Subject: Response to Administratively Incomplete Determination Part A and General Part B of the Resource Conservation and Recovery Act (RCRA) Permit Renewal Application Los Alamos National Laboratory EPA ID#NM0890010515, HWB-LANL-20-001

**Response to Administratively Incomplete
Determination Part A and General Part B of the
RCRA Permit Renewal Application Los Alamos
National Laboratory EPA ID#NM0890010515,
HWB-LANL-20-001**

Attachment 5
5-Year Averaged Wind Roses for Day and Night at LANL (2016-2020)

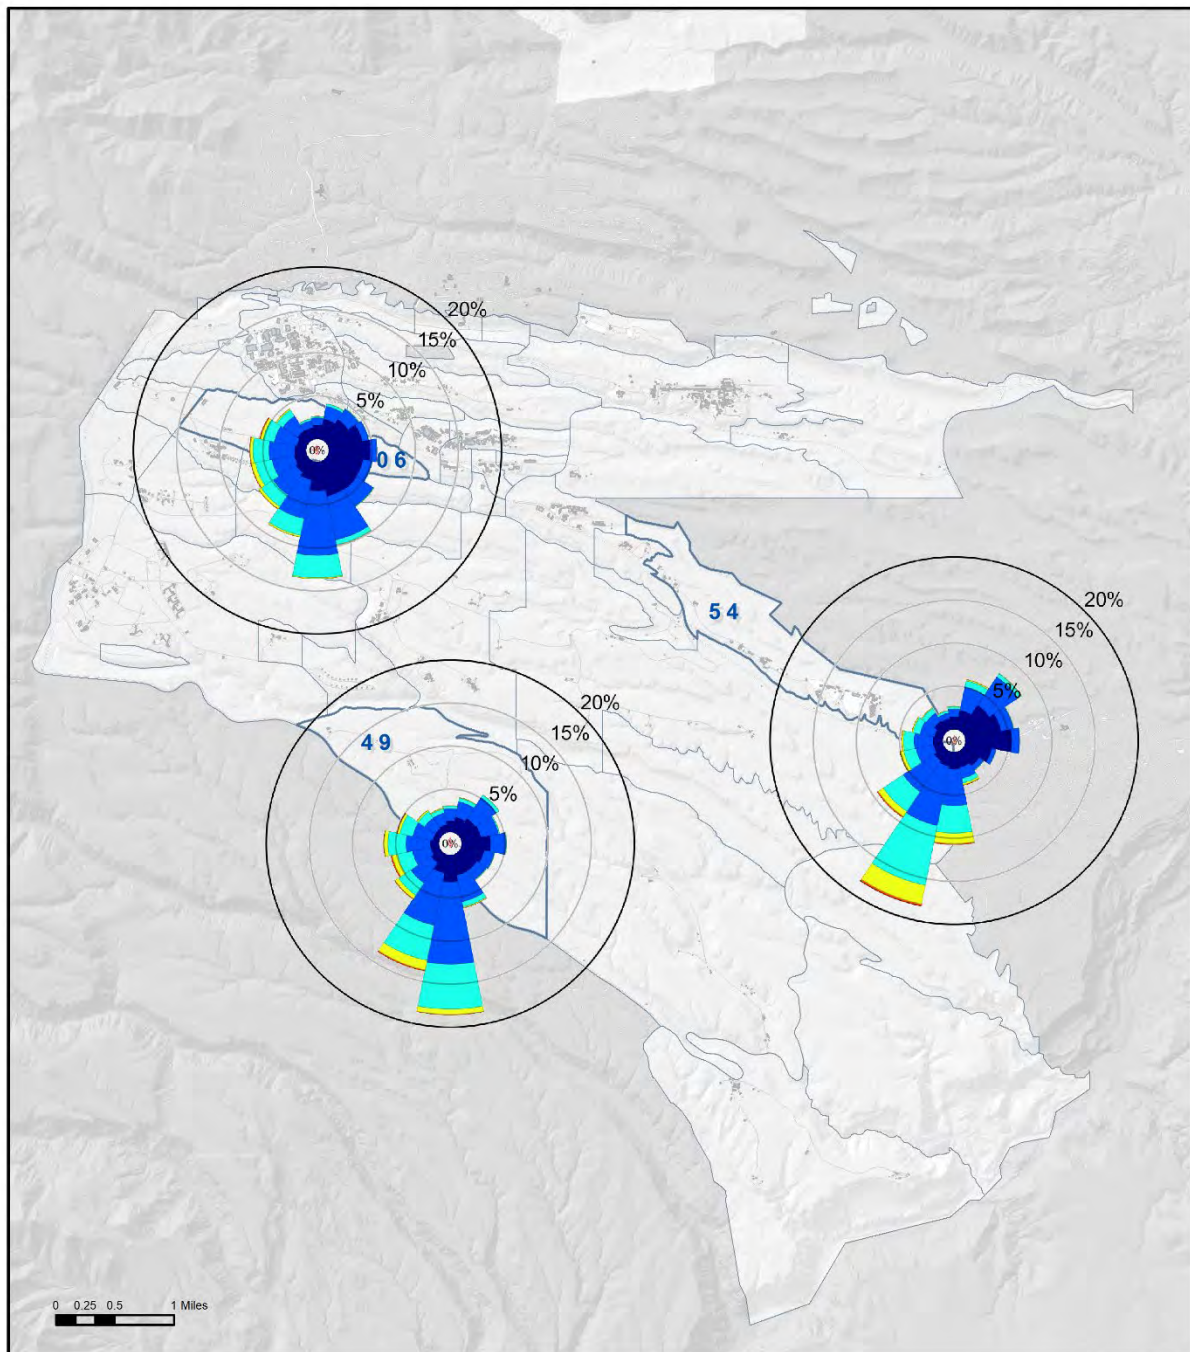
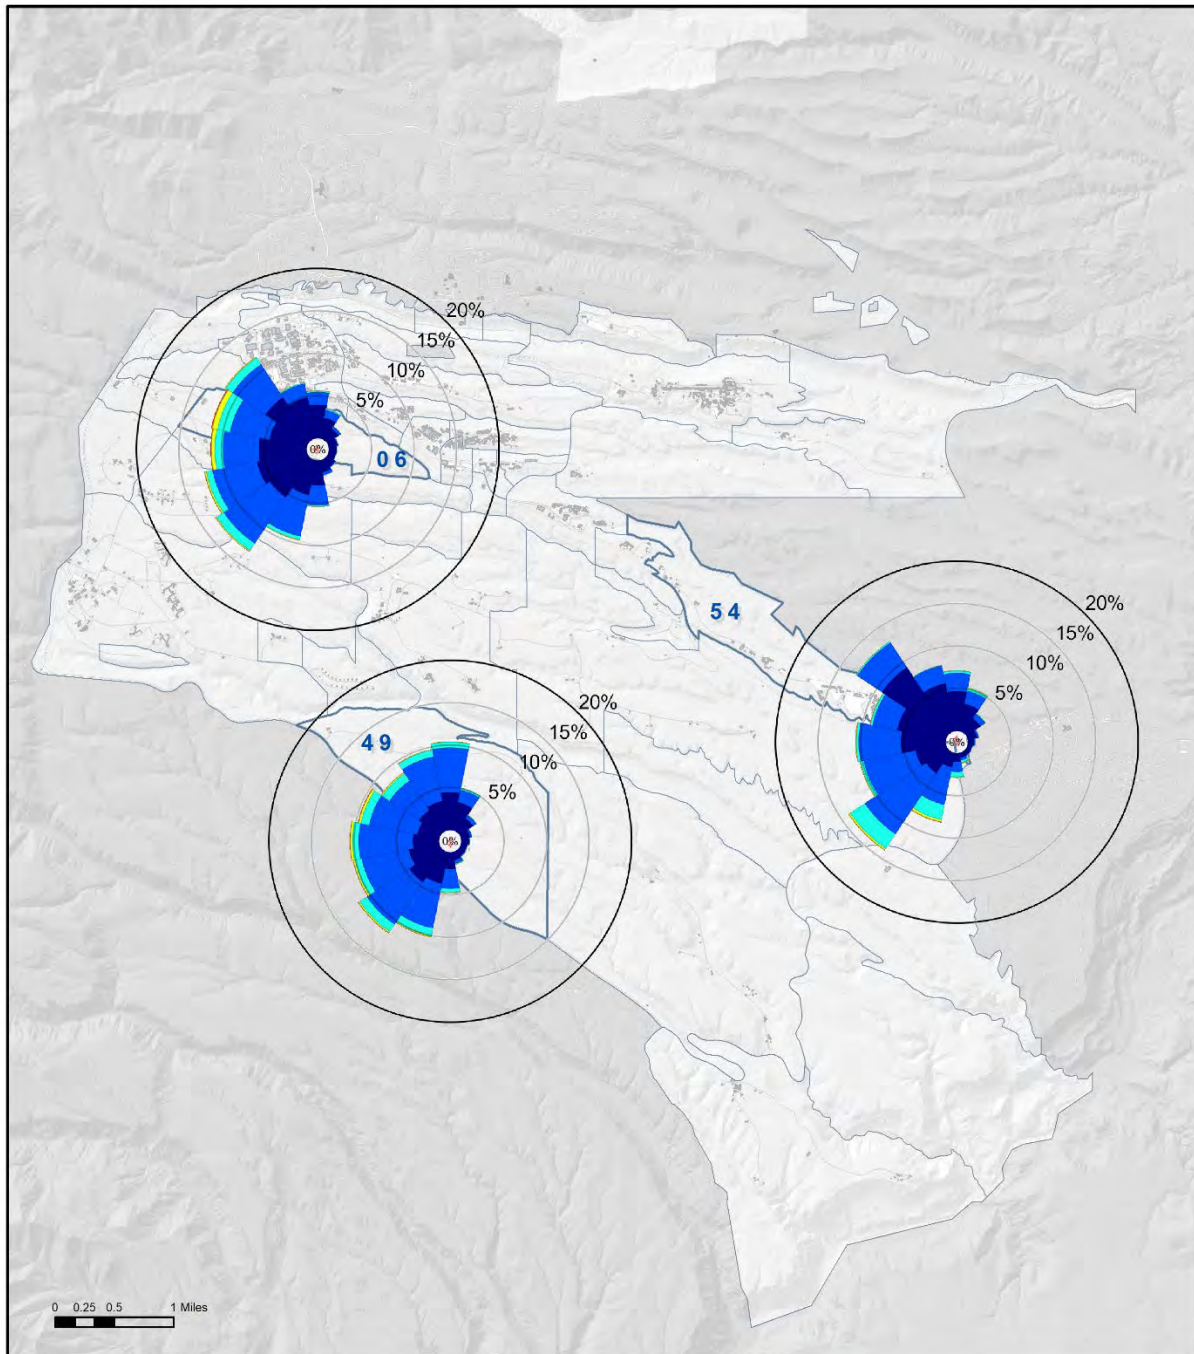
7. Section 2, Figure 2-3 Wind Roses (Day and Night), page 2-24:

The Permittees have not provided adequate information regarding the wind roses referenced in Sections 4, 5, and Supplements 4-3 through 4-9, -12, and -13. It is unclear when the data used to generate these wind roses was collected, and how many total days of data are compiled in the figure (e.g., a single year of data, or the average of five years of data). The Permittees must revise this Application to provide additional details on what year or years are represented by the day and night wind roses. Wind roses appear to have been calculated based on data from meteorological stations distant from the proposed OB/OD units. Please provide a rationale explaining why these monitoring locations are

Permit Renewal Application Figure 2-3 is revised (in Attachment 4) to include the year and total days that the wind roses were based upon. These wind roses were drafted based on winds from all 365 days of 2018. In general, wind roses from different years are almost identical in terms of the distribution of wind directions, indicating that wind patterns are constant when averaged over a year. As detailed in the Los Alamos Climatology 2016 Update (<http://permalink.lanl.gov/object/tr?what=info:lanl-repo/eprr/ESHID-602502>), there are four meteorology towers on the mesa tops at LANL at TA-6, TA-49, TA-53, and TA-54. The TA-53 location was not included in the Permit Renewal Application figures because it was deemed to be too far from any of the hazardous waste management units within the Permit or units in interim status. The other three meteorology towers are included in the Permit Renewal Application because they are the closest towers to the permitted and interim status hazardous waste management units. The distance for the TA-6 tower to the interim status units is: TA-36-8, ~4.26 miles; TA-39-6, ~5.5 miles; and TA-16-388, ~1.4 miles. The distance from the TA-49 tower to the interim status units is: TA-36-8, ~1.13 miles; TA-39-6, ~2 miles; and TA-16-388, ~3 miles. For completeness and comparison, the day and night 5-year averaged wind roses for 2016 through 2020 are included as Attachment 5 of this response. The 5-year wind rose data further illustrate that the wind rose information for each of the towers demonstrate very little difference with the exception of the 2018 wind roses that show slightly more intense winds over the single year average compared to the 5-year average.
